COUNTRY CLUB ESTATES SUBDIVISION, FIFTH UNIT, REVISED LOT 16

APPLICATION NUMBER 3 DATE September 20, 2018

REQUEST Subdivision

DETAIL SITE PLAN

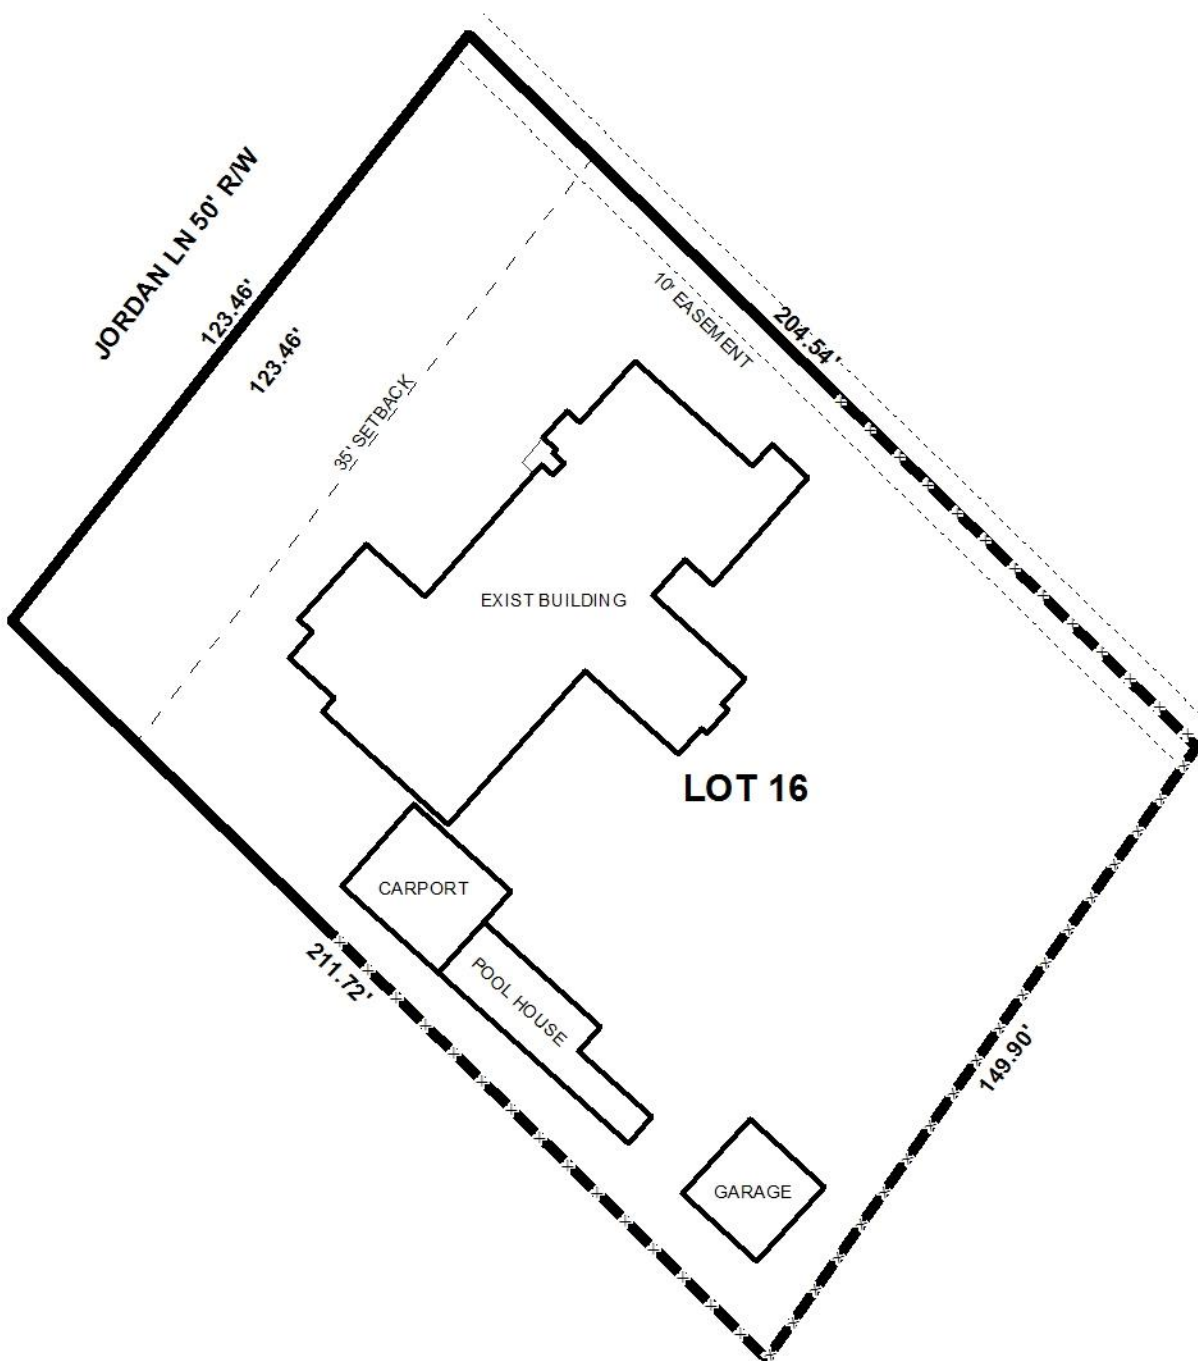
The proposed lot fronts Jordan Lane, a minor street requiring a 50' right-of-way width. The preliminary plat illustrates a 50' right-of-way width on Jordan Lane and, if approved, should be retained on the Final Plat.

A 35-foot minimum building setback line along Jordan Lane is depicted on the preliminary plat. The existing Subdivision, New Country Club Estates Subdivision 5th and 6th Units (recorded in 1954), required a 50' front yard setback. However, the adjacent property to the East however, is located 35' from the front property line and other units, specifically Unit One of New Country Club Estates, which adjoins the site to the West, according to the applicant, was recorded with a 35-foot setback. The applicant wishes to amend the previously recorded front yard setback to allow for an addition on the front of the existing dwelling. If approved, the 35' front yard setback should be retained on the Final Plat.

The proposed lot exceeds the 7,200 square foot minimum lot size requirements for lots served by public water and sanitary sewer systems. The preliminary plat does not provide the lot size in square feet and acres. If approved, provision of the lot size information in square feet and acres will be required on the Final Plat.

As a means of access management, a note should be placed on the Final Plat, stating that the lot is limited to one curb cut, with size, location and design to be approved by Traffic Engineering and conform to AASHTO standards.

- 1) Retention of the 50' right-of-way width to Jordan Lane;
- 2) Retention of the 35' minimum building setback line along Jordan Lane;
- 3) Provision of lot size information in both square feet and acres;

- 4) Placement of a note on the Final Plat stating that the lot is limited to one curb cut, with the size, design and location to be approved by Traffic Engineering and conform to AASHTO standards;
